MARK	DATE	DESCRIPTIONS	MP	RR	42
1	02/19/08	ELECTRICAL MODIFICATIONS	EL	RR	42
REVISIONS			BY	CH'D	CCO#

CONTRACT CHANGE ORDER NO. _____
 SHEET _____ OF _____

DETAILS
TOWER AND SUSPENSION CABLE
TOWER POWER AND LIGHTING
 SCALE AS NOTED

E-264

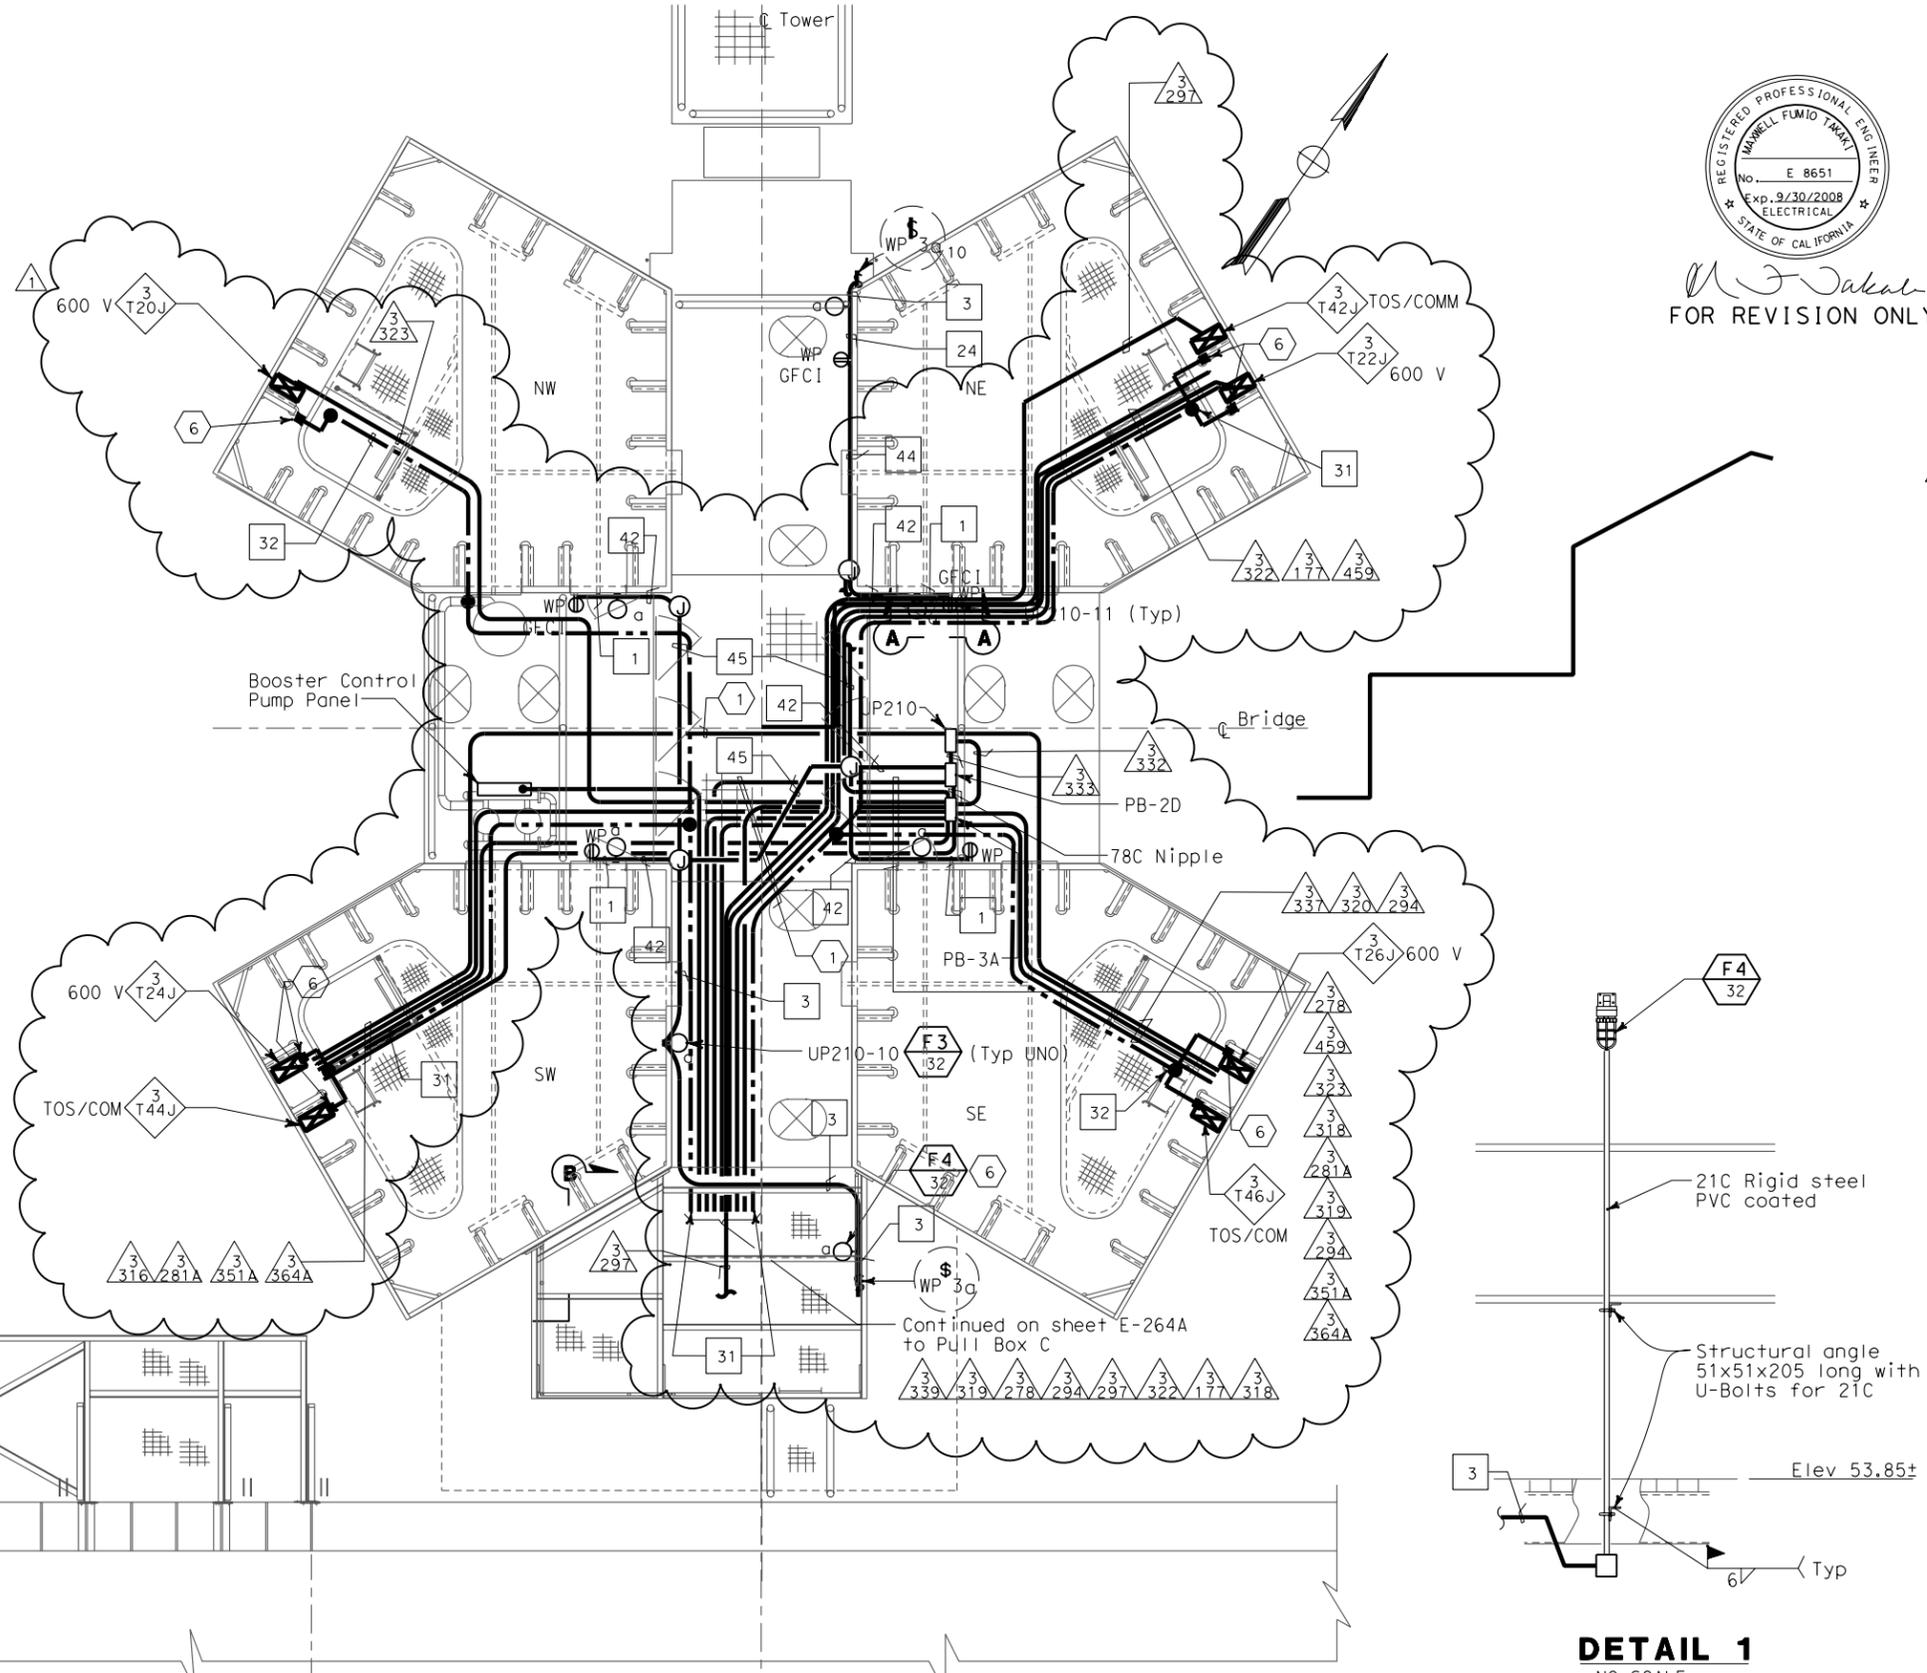
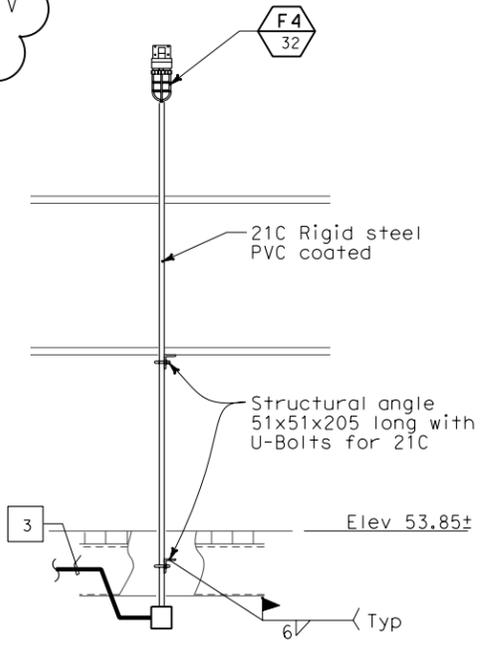
- SHEET NOTES:**
- All conduits which thereafter cross the access walkways shall be raised to a level of at least 2438 above the grating to pass overhead, allowing free walkways on the remaining three quadrants of the platform. Door on north face of SE tower shaft shall remain accessible.
 - Down to elev. 3.0 m, see sheet E-231.
 - For continuation, see sheet E-266.
 - See Detail 1, this drawing.
 - 250 kcmil Copper conductor down to Elevation 3.0 Sheet E-231.
 - #4/0 Bare copper conductor bonded to all cable trays (Typ.)
